**Special Service Campaign (SSC) 60F
2004 Through 2005 Highlander And Early 2006 Highlander HV
Center Console (Floor Carpet Cover) Retaining Clips
*****URGENT*******

Volume: XIII
Number: TC06-010
Date: 07/11/2006
 Action
 Retain
 Information

SUBJECT: SPECIAL SERVICE CAMPAIGN (SSC) – 60F (SAFETY RECALL)
2004 THROUGH 2005 HIGHLANDER AND EARLY 2006 HIGHLANDER HV
CENTER CONSOLE (FLOOR CARPET COVER) RETAINING CLIPS

SPECIAL SERVICE CAMPAIGN 60F

IV. COMPONENTS

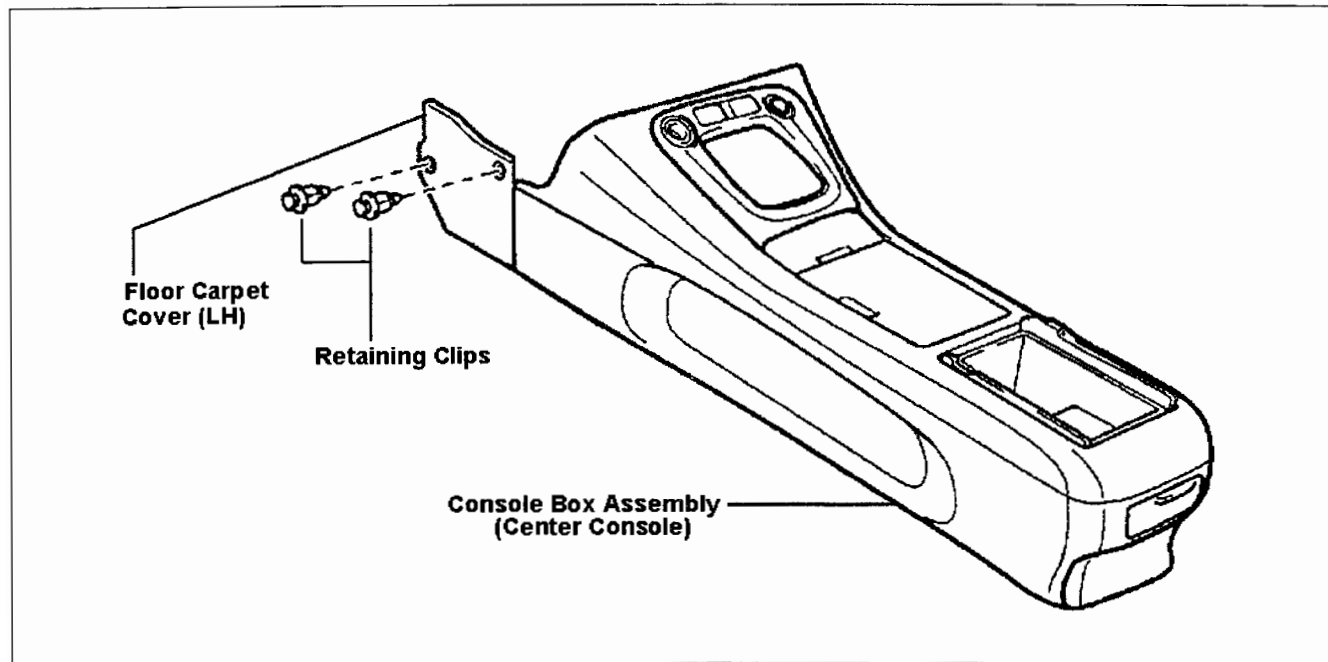
In certain 2004 through 2005 model year Highlander and early 2006 model year Highlander Hybrid (HV) vehicles, due to improper installation, the two Retaining Clips for the driver's side forward Center Console (Floor Carpet Cover) can become loose. If both clips separate from the Floor Carpet Cover, the cover may lean toward the accelerator pedal, causing interference with the accelerator pedal rod.

Part Number	Part Description	Quantity
04006-26148	Package of 2 Retaining Clips	1

1. REMOVE THE CLIPS

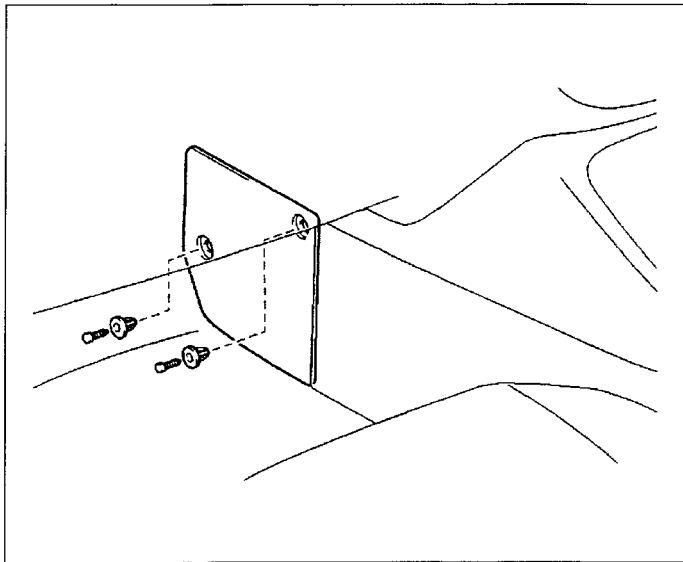
- a) Remove, **destroy** and **discard** the 2 clips.
